**RUTHERFORD + CHEKENE**

**UC Santa Cruz building seismic ratings**  
**Visual Arts Facilities-Building L**

CAAN #7926

**Detailed joist-to-column connection (Detail 11 and 15 per Sheet S301)**

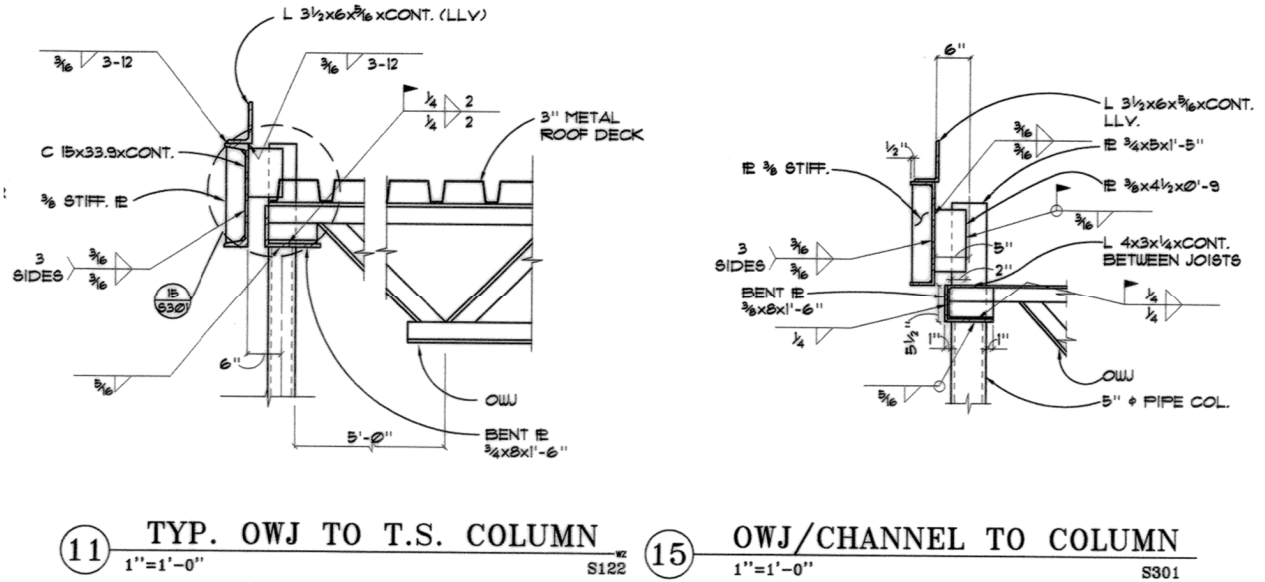
- The joist-to-column connection detail is different from the detail shown in the structural drawings. The main differences are: (1) an angle was welded at the end of the joist; one leg is welded above the top chord of the joist and the other to the top of the bearing plate (see the pictures in Appendix A), this angle connects all the steel columns; (2) A vertical steel plate was welded to the end of the joist to stiffen the top chord and to transfer vertical load; (3) Two thick bearing plates were welded to the column horizontal plate. During the site visit, it was not possible to inspect the welds used in this connection. Without closer inspection, it is not clear if there is a compliant positive tie from the joist to the bearing plate and then from the bearing plates to the column cap plate.

**Roof-to-wall connection (Details 7/S301 and 9/S303)**

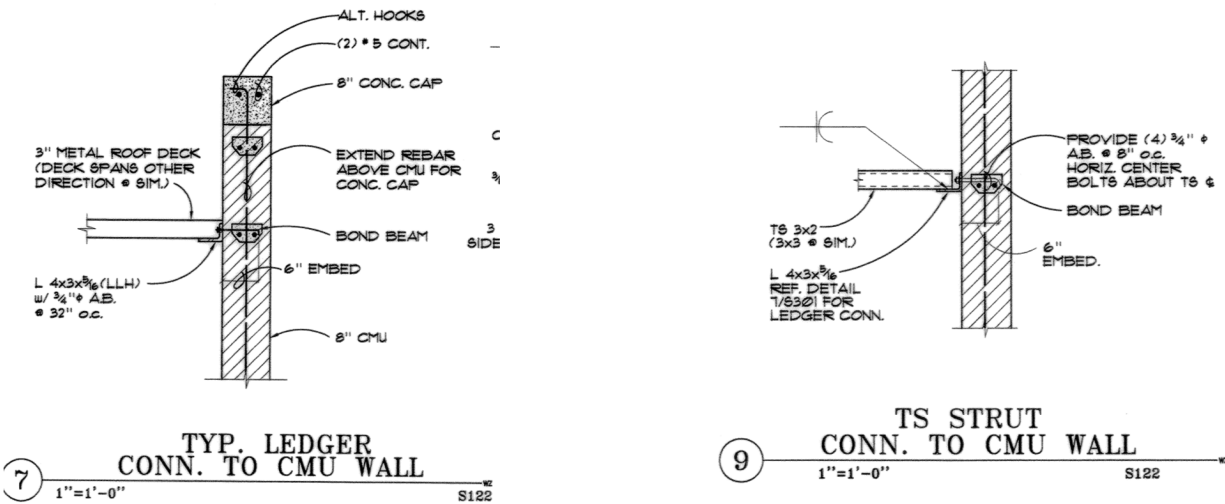
- Roof-to-wall tie: The typical roof-to-wall tie per Detail 7/S3.01 at the west and east walls relies on puddle welds from the deck to the top of an L4x3x3/8" ledger which are connected with 3/4" diameter bolt at 32" o.c. to a bond beam in the CMU wall. In addition, there are two concentrated tube-to-wall connections along the wall length per Detail 9/S3.03 that use a similar approach as Detail 7/S3.01, but with four anchor bolts centered about the tube. At the south wall, the deck flutes are parallel to the wall, so the only out-of-plane tie is from the open web joists to a pocket in the wall per Detail 9/S3.01. At the pocket, the top chord of the joist bears on a base plate which has two 3/4" anchor bolts into the CMU wall which resist loads in shear. Information showing how the top chord of the joists is connected to the base plate is missing.
